**MANDATORY
SERVICE BULLETIN**

DATE: May 6, 1957 Service Bulletin No. 183A
(Supersedes Service Bulletin No. 183)

SUBJECT: Magneto Timing Discrepancies

MODELS AFFECTED: All Lycoming Opposed Series Aircraft Engines.

Figure 1 - Alignment of Notched Tooth and Pointer

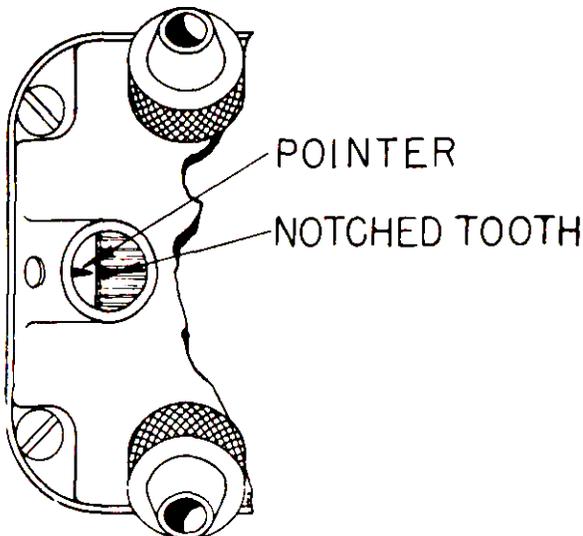
We have received complaints of faulty engine performance, burnt pistons and engine failures that were traced directly to improperly timed ignition and inadequate ignition inspection. In many instances this condition is caused by improper technique on the part of personnel engaged in making periodic inspection or adjustment to the ignition timing. Apparently, it is the belief of some individuals that an engine is correctly timed if: (1) number one cylinder is on its compression stroke (2) ignition timing marks on the engine are in alignment (3) the pointer and white notched tooth as viewed through the window of the magneto, are in alignment. This is not true.

The degree of accuracy necessary to correctly time the ignition cannot be achieved by this method. The white notched tooth and the pointer on the magneto as shown in figure 1 are provided only as a means of correctly positioning the magneto during its assembly on the engine and are definitely not intended as an indicator of the point of breaker opening.

This is accomplished only by the use of a timing light to indicate point of breaker opening and close adherence to instruction on ignition timing referenced in the handbook applicable to the particular engine model. Furthermore, when ignition timing marks are inaccessible or engine parts having ignition timing marks have been replaced, we recommend positioning the crankshaft relative to degrees before top dead center by using Time-Rite Piston Position Indicator.

Figure 2 - Adjusting Breaker Point Clearance on Heavyweight Magnetos

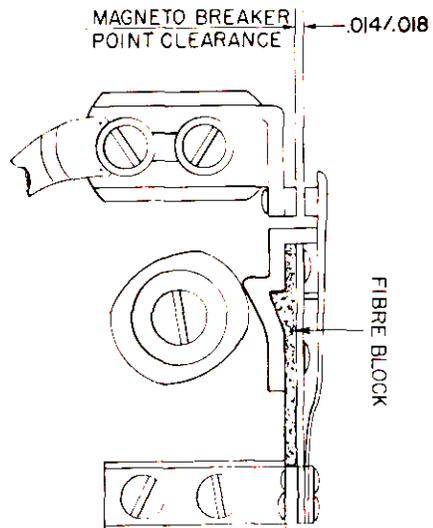
On engines with heavyweight magnetos, if it is found the magneto breaker point clearances have closed due to wear of fiber block, check the point gap, using feeler gages, and adjust to no less than .014 inch or to no more than .018 inch. (See figure 2). If it is necessary to adjust the points; it will also be necessary to recheck the ignition timing, using the timing light and in accordance with the instructions in the applicable engine manual. Breaker points on lightweight magnetos are not to be adjusted to a given clearance.
